DESIGN REVIEW APPROVAL NOTICE

This notice is provided pursuant to Alameda Municipal Code (AMC) Section 30-36.3 to declare that on March 19, 2018, the City of Alameda approved Design Review Application No. **PLN18-0484** at 1123 Versailles Ave. This determination has been made following a review for consistency with the City of Alameda's Zoning Ordinance and Design Review Manual.

**Residential Addition
& Remodel**
1123 Versailles
Alameda, CA 94501

A.3

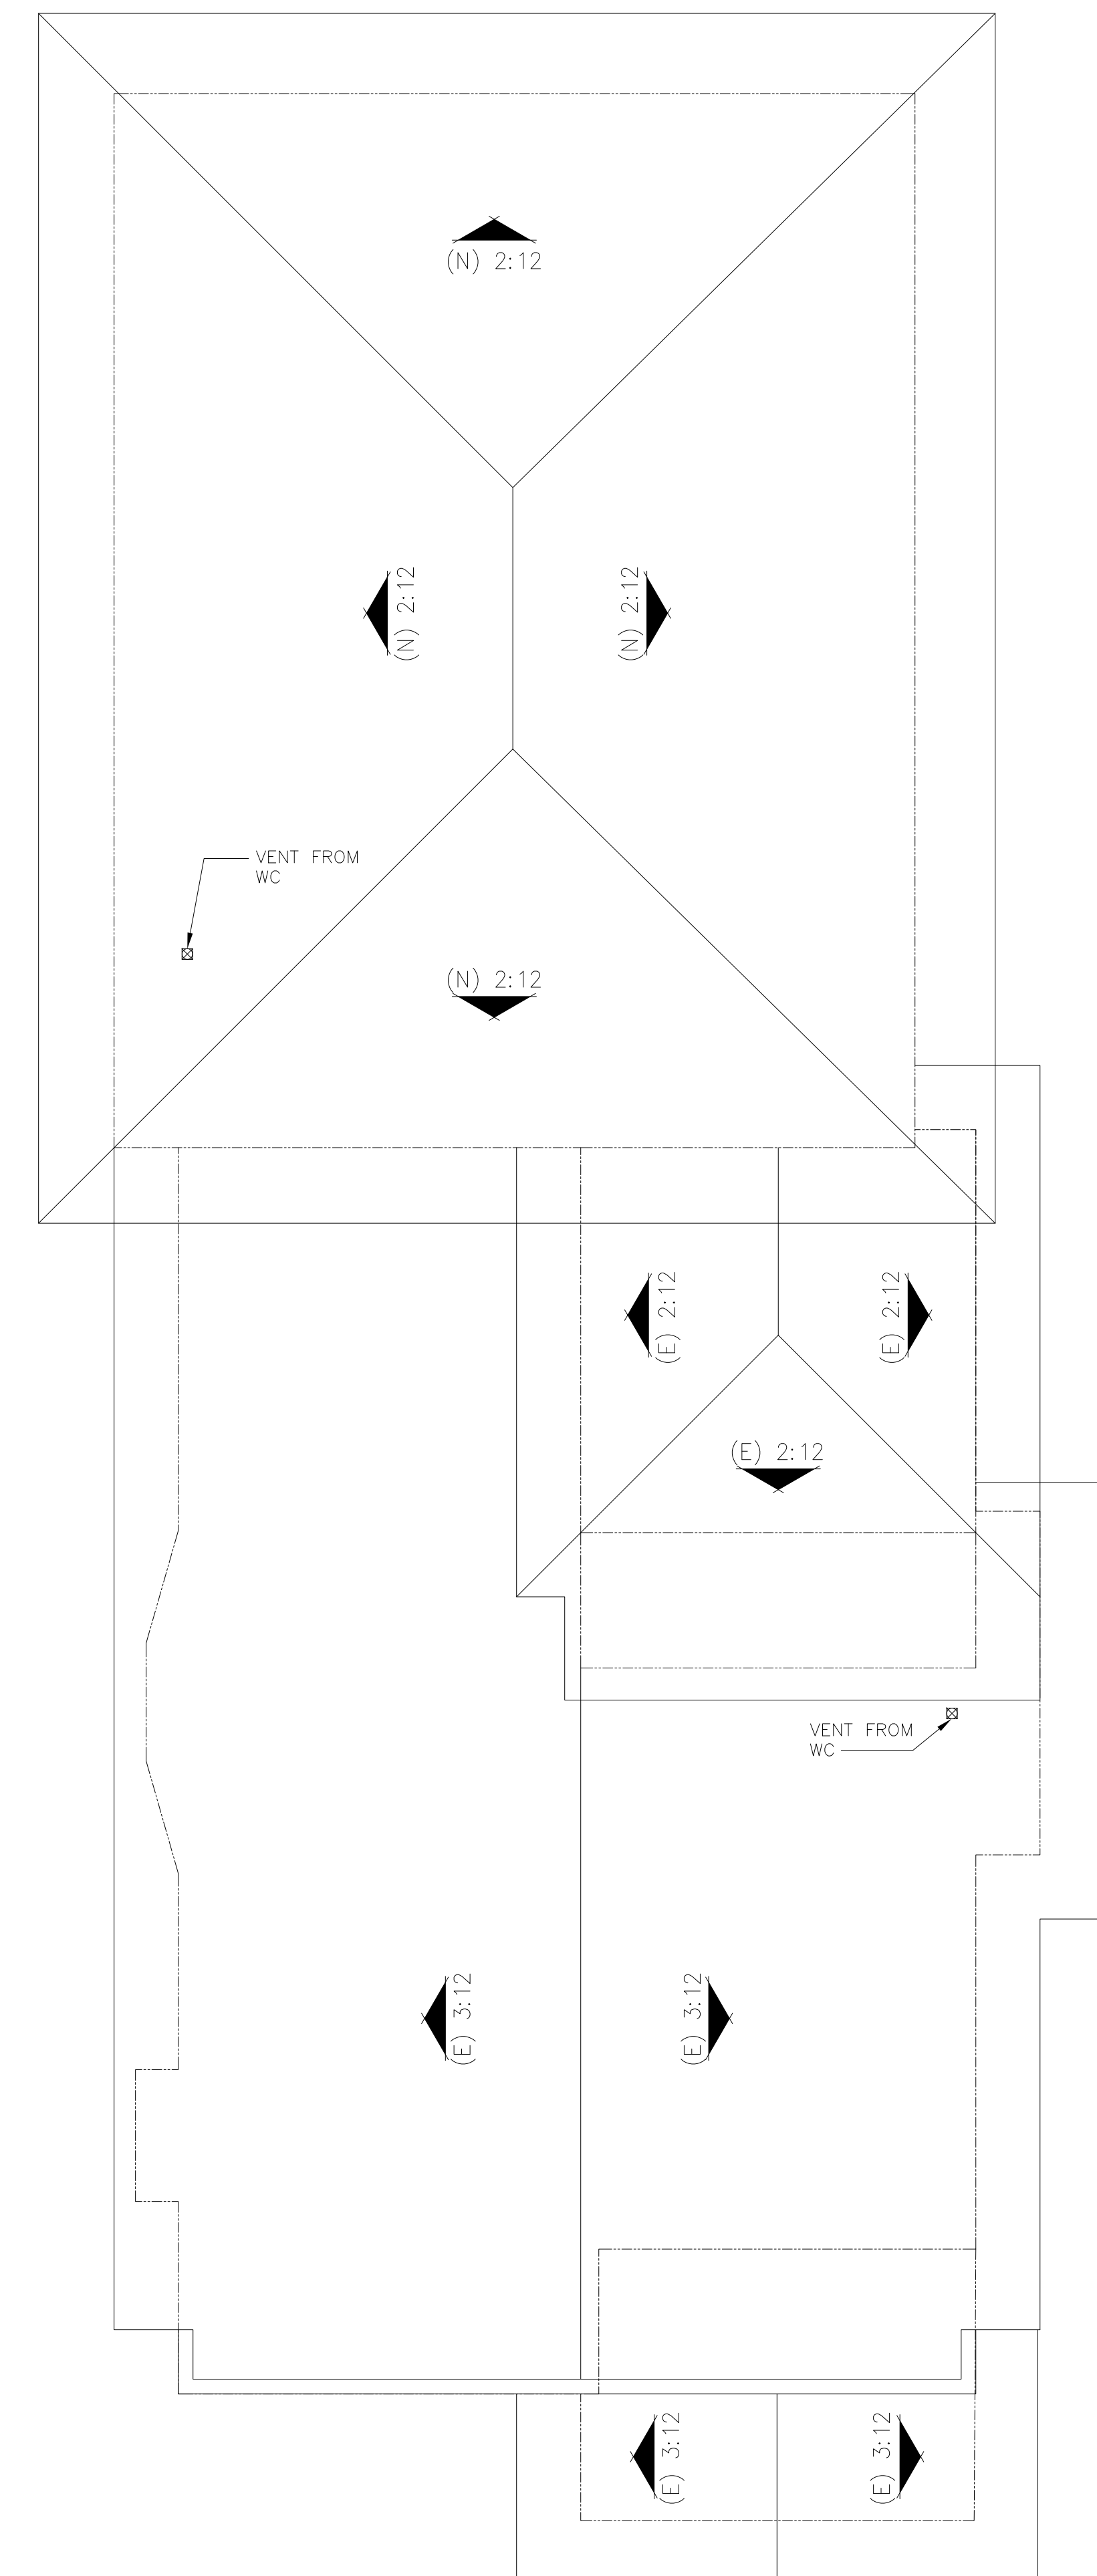
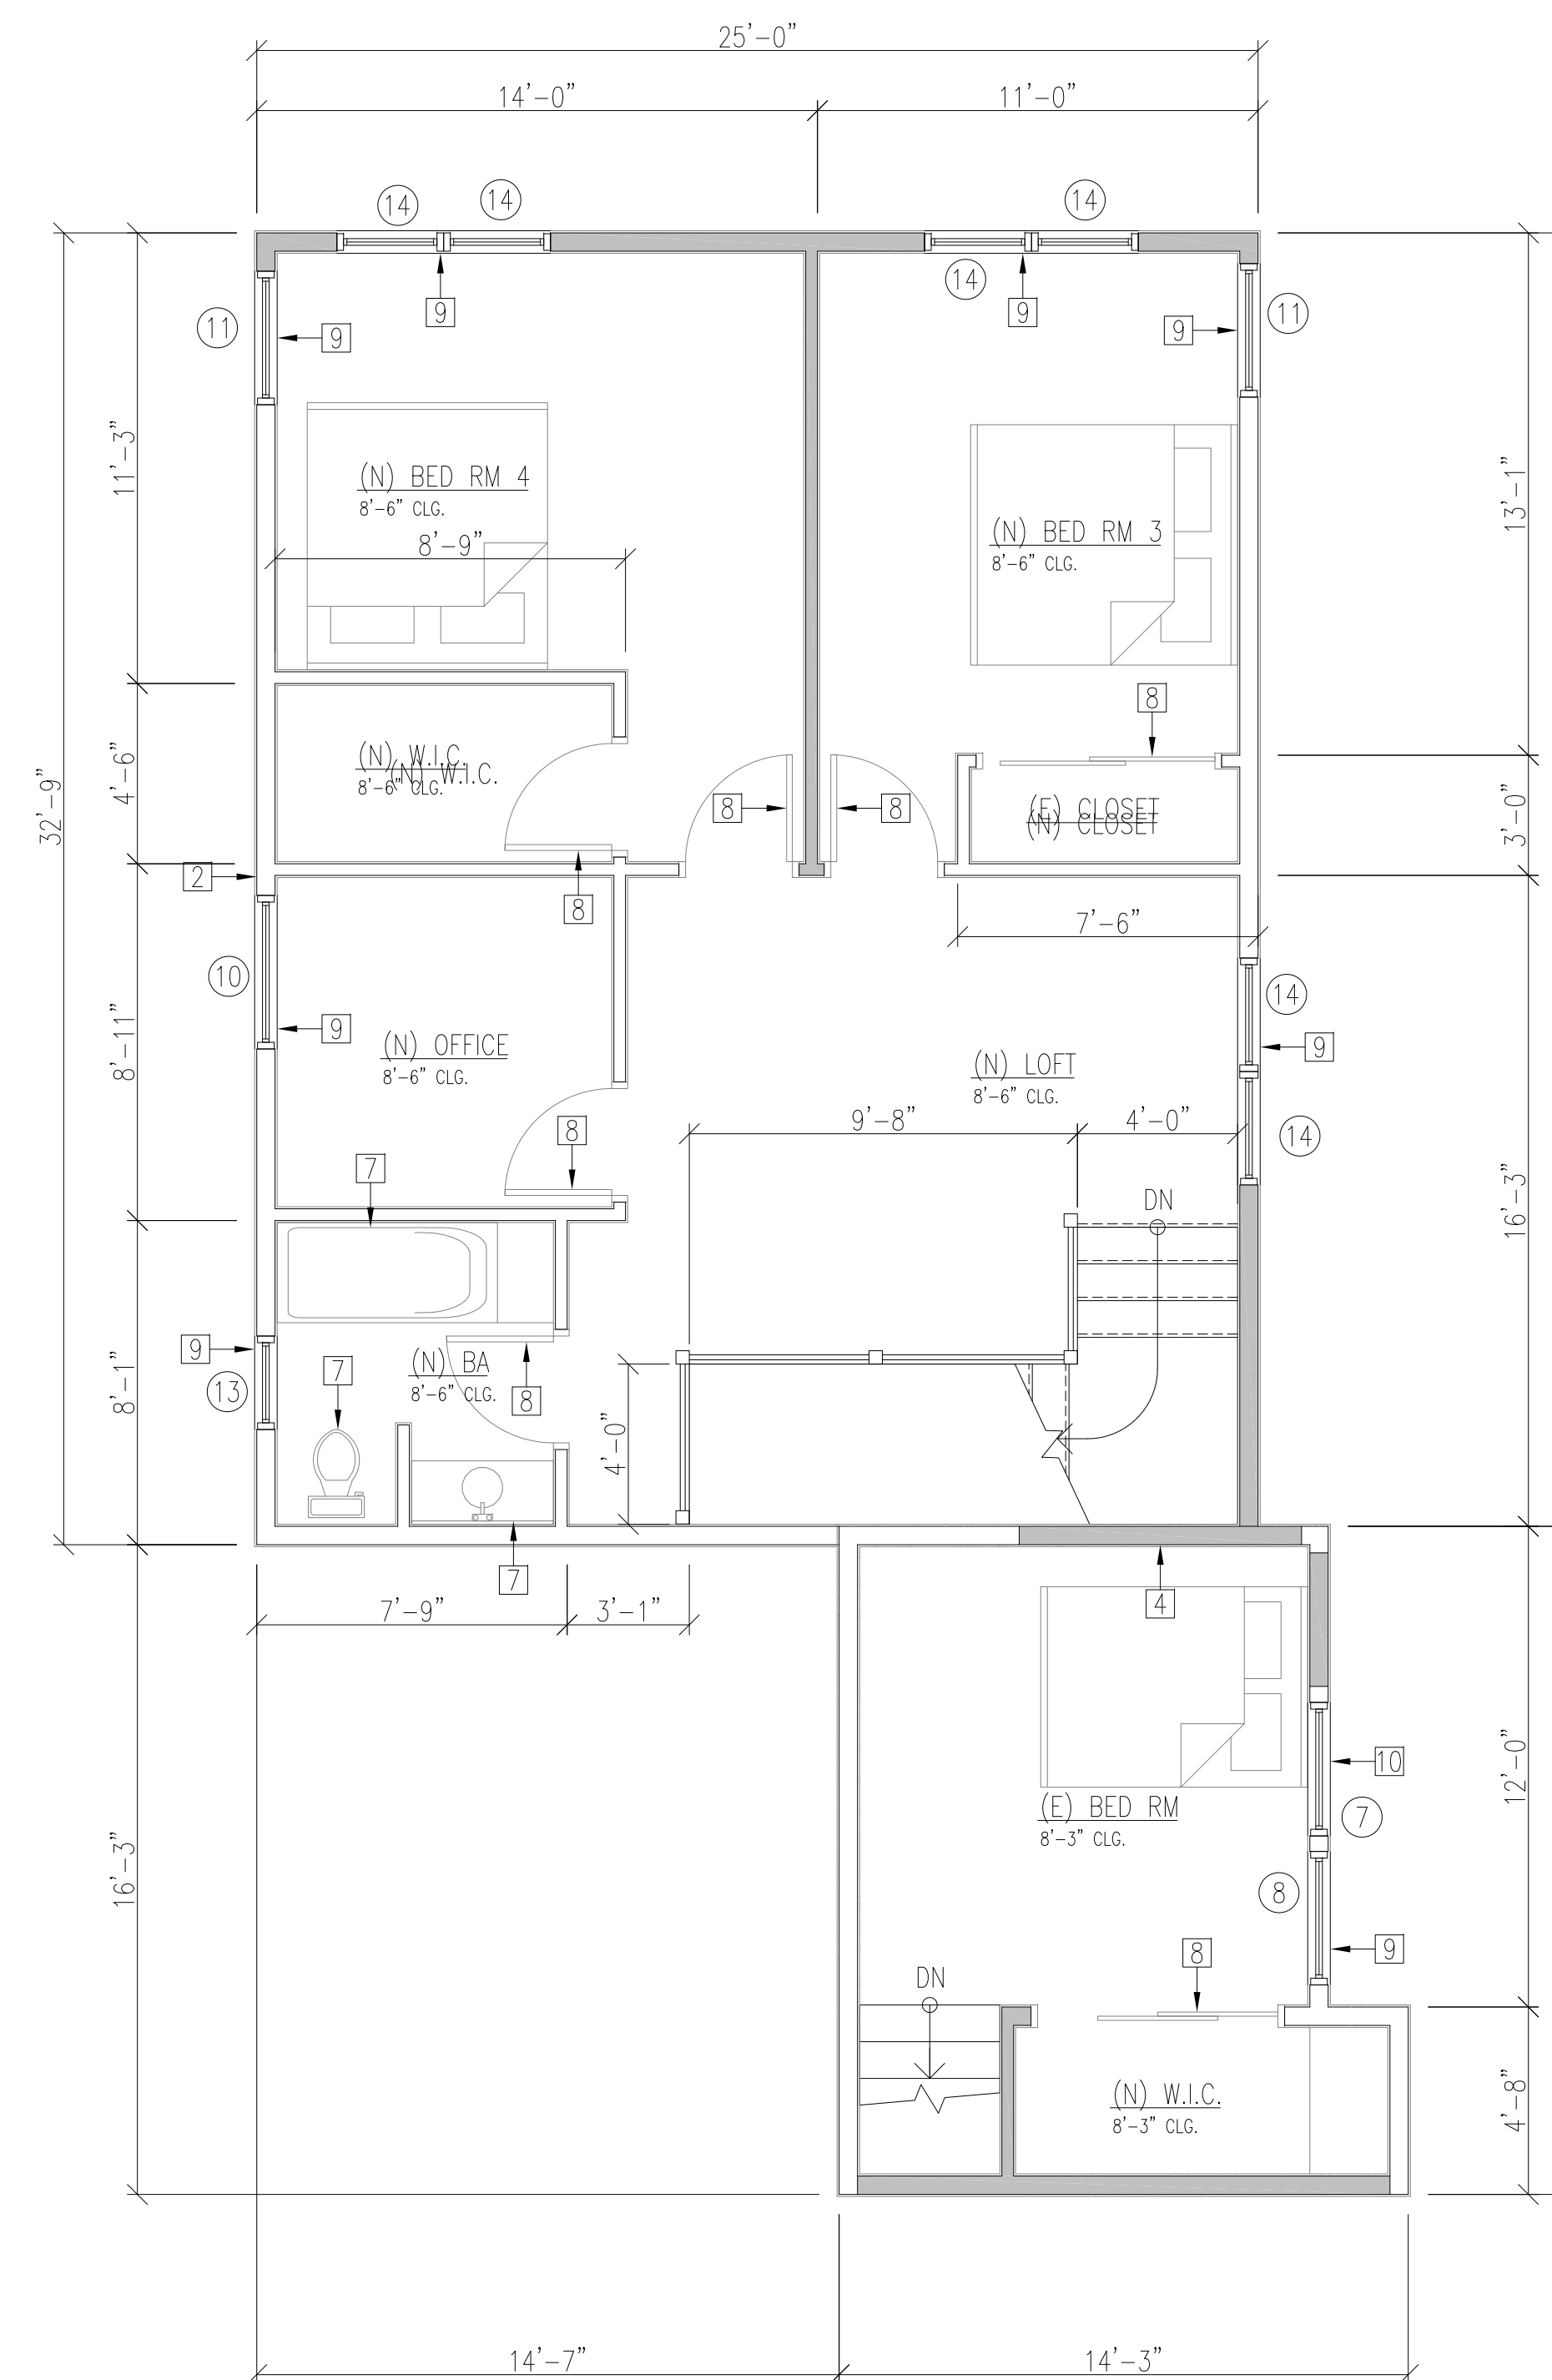
- (6) The final plans submitted for Building Permit plans shall incorporate the approved window schedule, with the following correction:
 - a. Proposed windows labeled #10, #11, and #13 on Sheet A.3 shall be modified to be clerestory windows located to maximize privacy between neighboring properties and still provide for light and ventilation.

1 SECTION
Scale: 1/4"=1'-0"

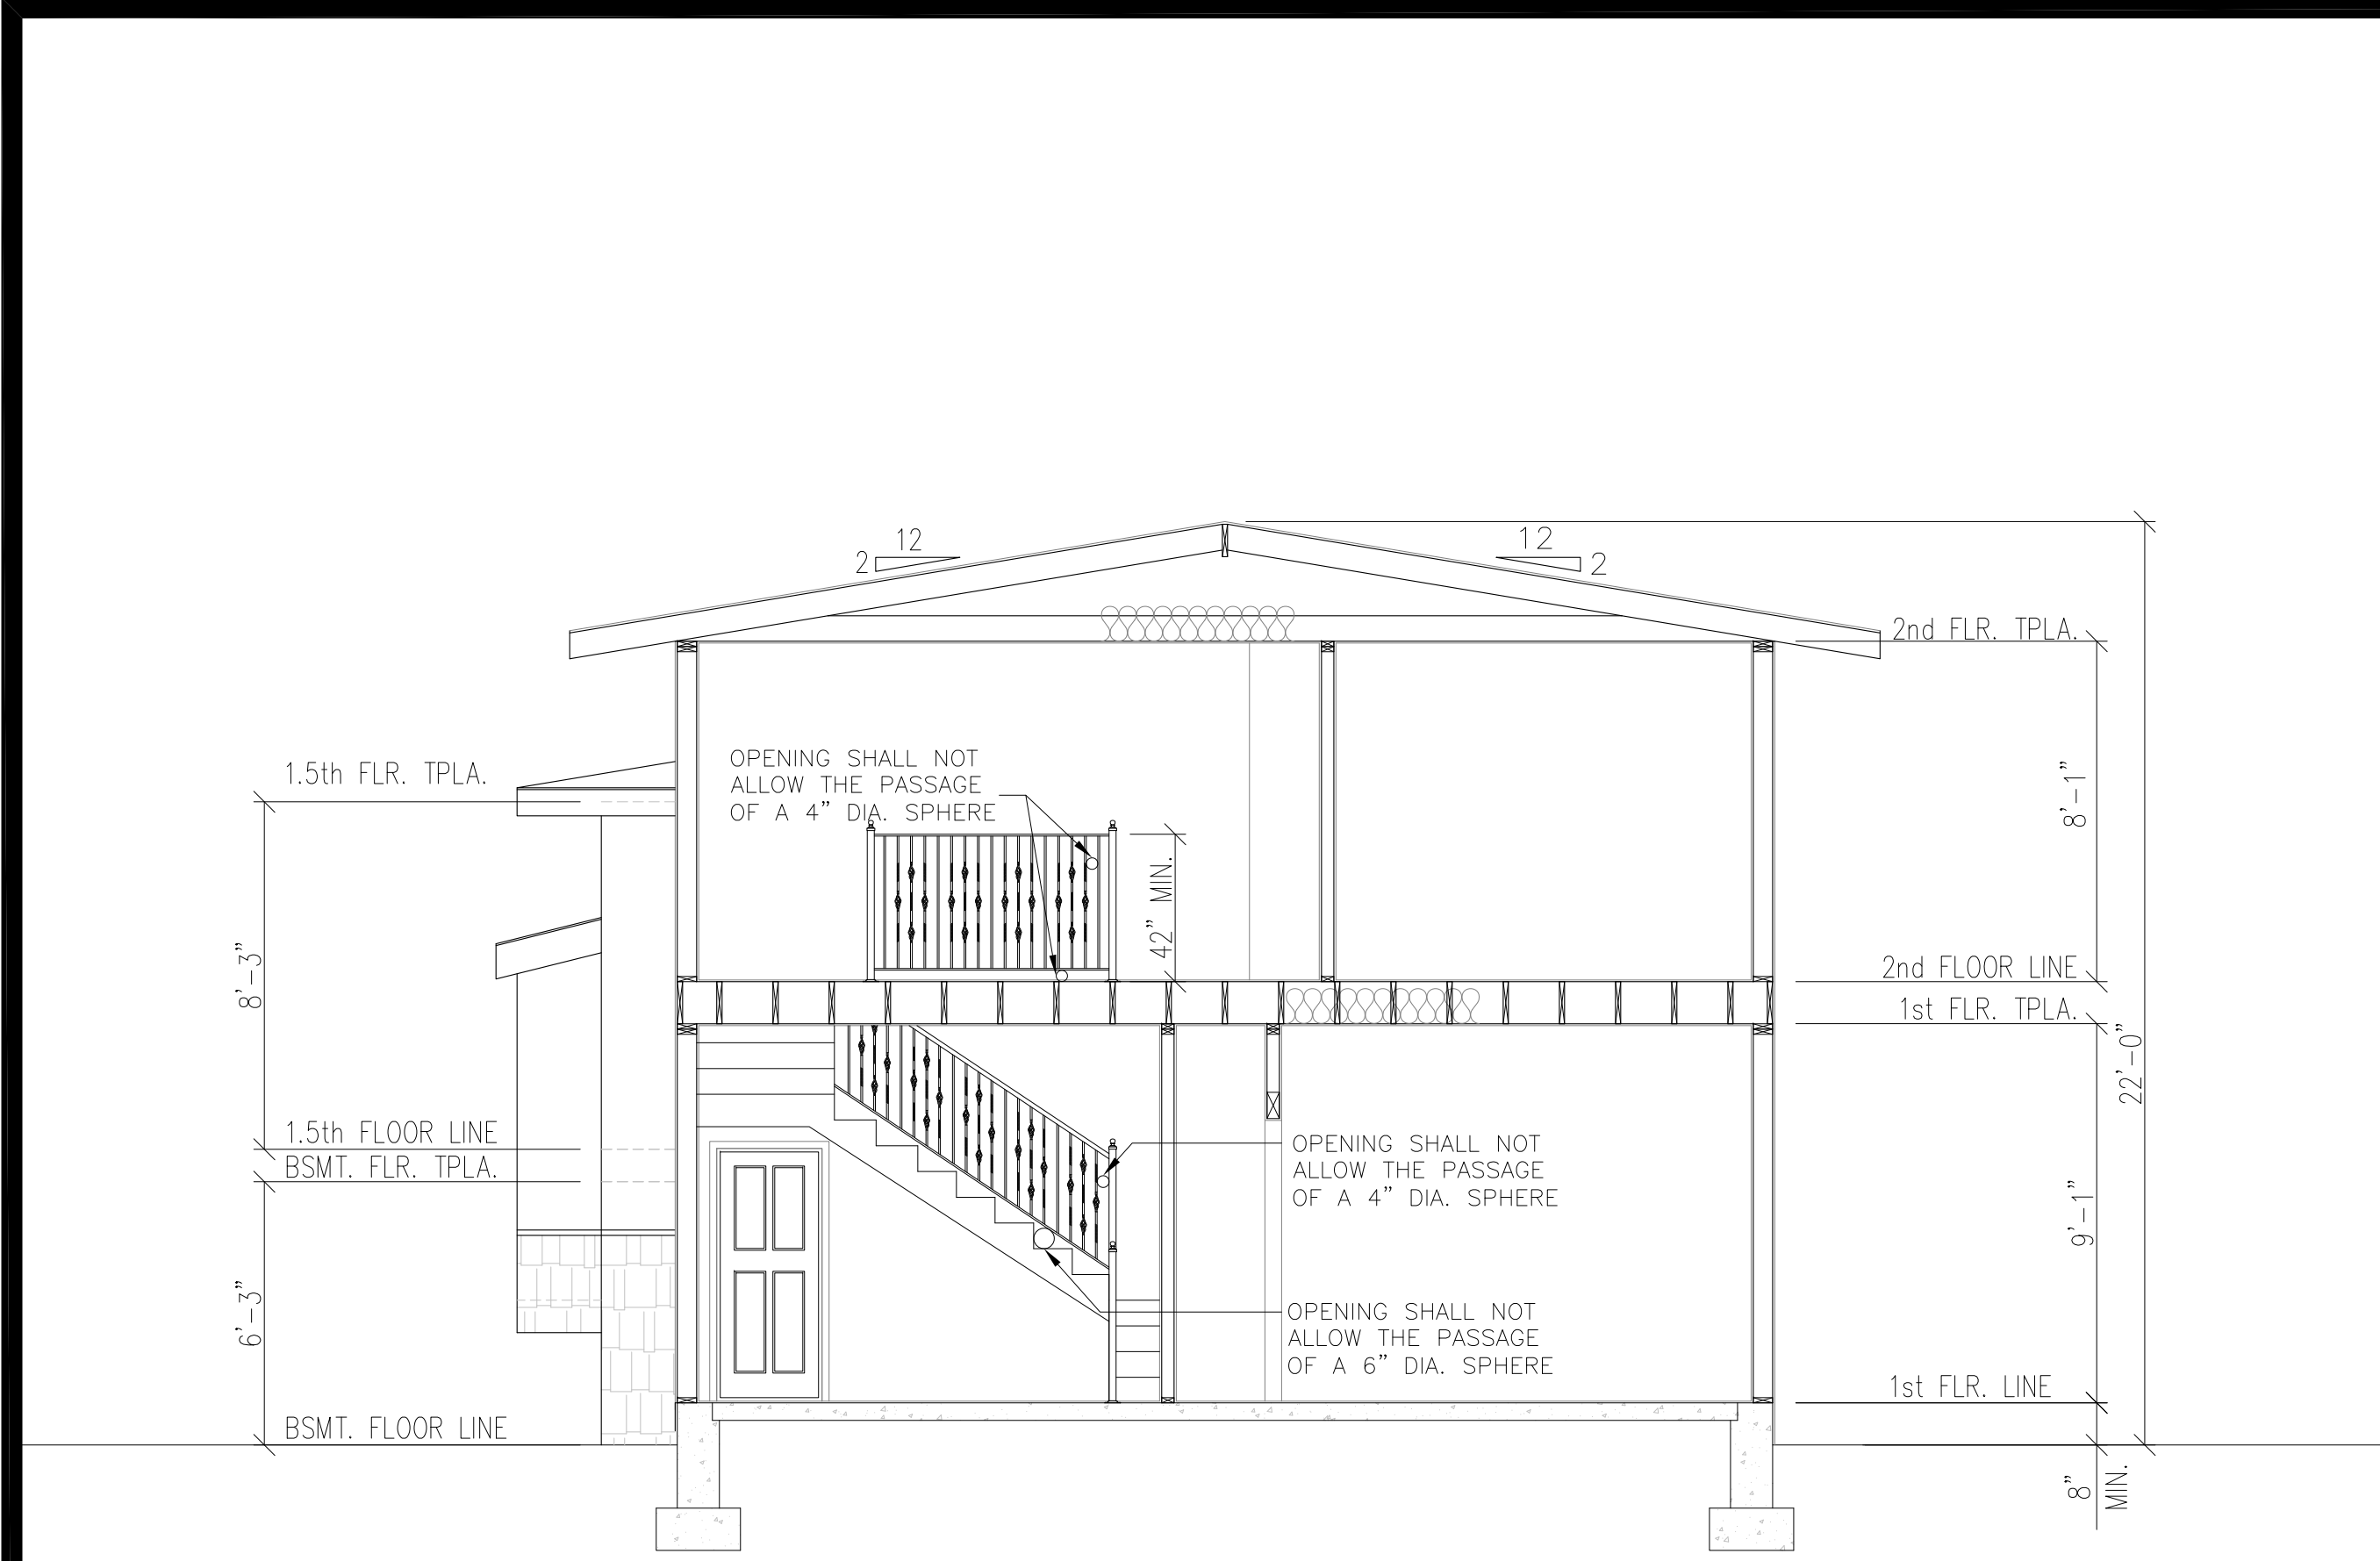
- (5) The final plans submitted for Building Permit plans shall demonstrate that the lower floor of the addition has been reduced to a maximum height of eight feet and one inch (8'1") as measured from finished floor to top of plate.
